GENERAL NOTES:

1. The Contractor shall comply with all applicable safety regulations. All construction shall be completed following current City Standard Specifications and Special Provisions.

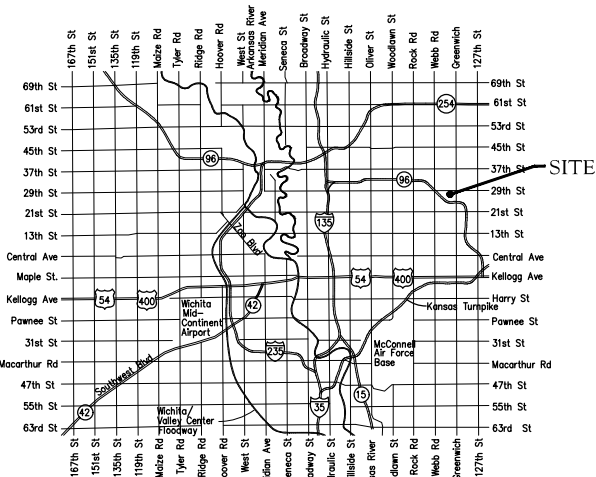
APPROVED AS NOTED  
BY WICHITA PUBLIC WORKS  
ENGINEERING DIVISION  
& BY WICHITA FIRE DEPARTMENT
